# WATER QUALITY MEMORANDUM

Utah Coal Regulatory Program

RE: 2006 Fourth Quarter Water Monitoring, Canyon Fuel Company, Soldier Canyon Mine, C/007/0018-WQ-06-4, Task ID #2681

Chloride

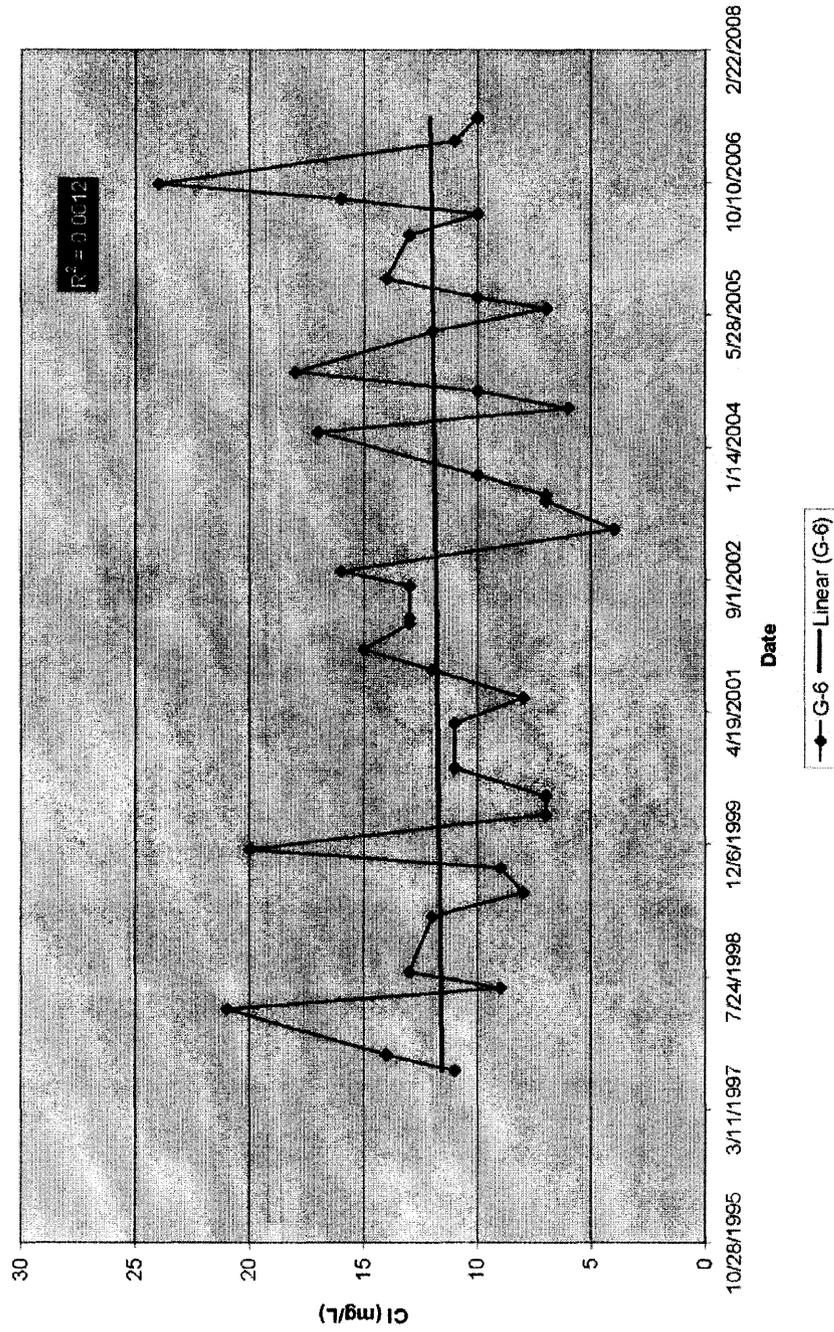
Chloride (24 mg/L) has no real trend at G-6 ( $R^2 = 0.0012$ ) nor correlation to flow ( $R^2 = 0.03$ ). This is the highest concentration of chloride ever recorded at this site, but a level of 24 mg/L is well below any water quality limits.

Carbonate

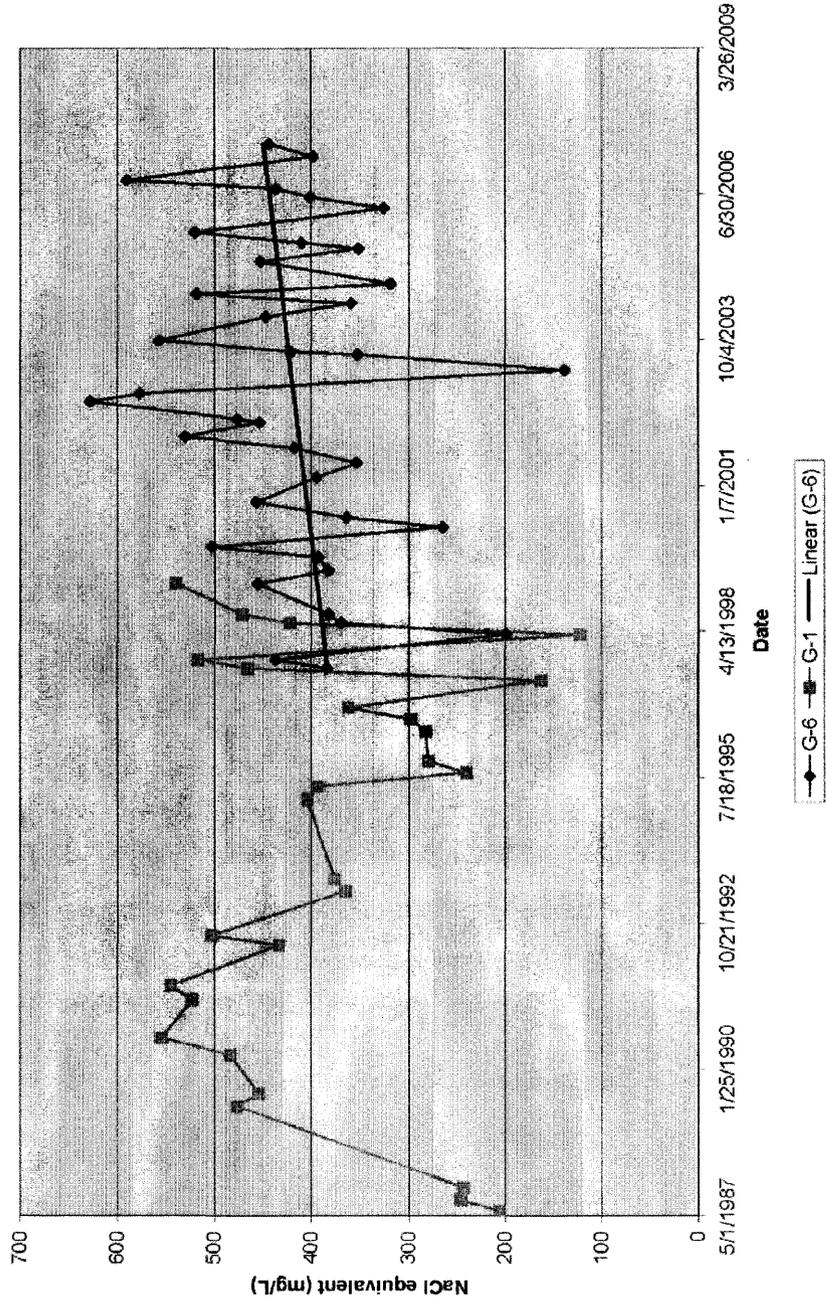
The alkalinity at G-6 has no real trend ( $R^2 = 0.0755$ ), with a weak negative correlation to flow ( $R^2 = 0.29$ ). Carbonate has a weak upward trend ( $R^2 = 0.3149$ ) and no correlation to flow. Alkalinity is a measure of buffering capacity, or the ability of a water-source to absorb acid

Salinity

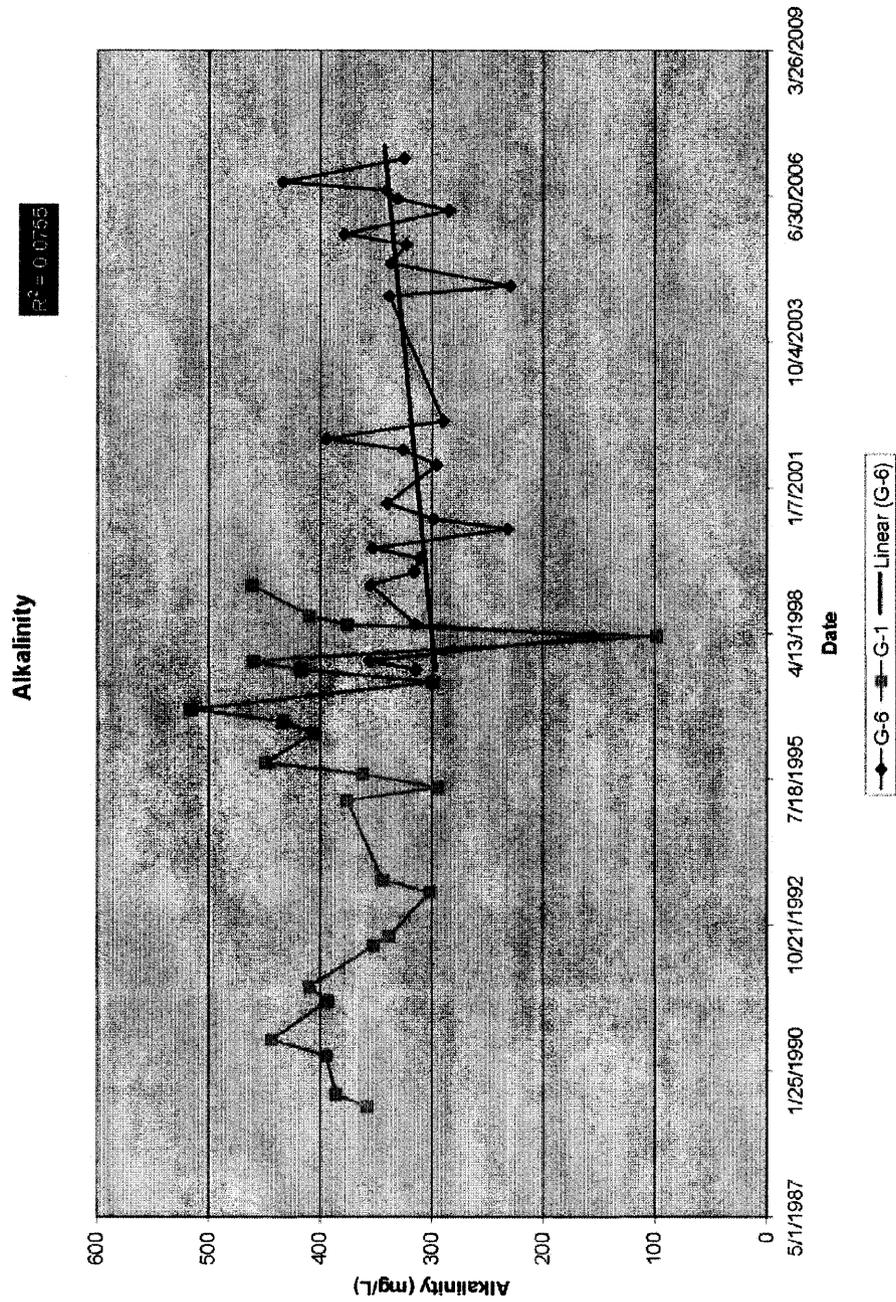
The salinity at G-6, which is affected by several parameters (Cl, Na, Mg, SO<sub>4</sub>, Ca, K, HCO<sub>3</sub>, etc.), has always been at the high end of "fresh" (<500 mg/L NaCl equivalent) and at times crosses into the "brackish" category (500-30000 mg/L NaCl equivalent). The average salinity has been approximately 415 mg/L NaCl equivalent with 21% of all samples >500 mg/L, 55% >400 mg/L, and 92% >300 mg/L. There is no real upward trend in salinity ( $R^2 = 0.0482$ ) and a weak negative correlation to flow ( $R^2 = 0.22$ ). Similarly high, fluctuating salinity values were recorded at G-1 (2 miles upstream) from 1987 to 1999. Samples taken at G-7 in the 1970's ranged from 385 to 635 mg/L NaCl equivalent.
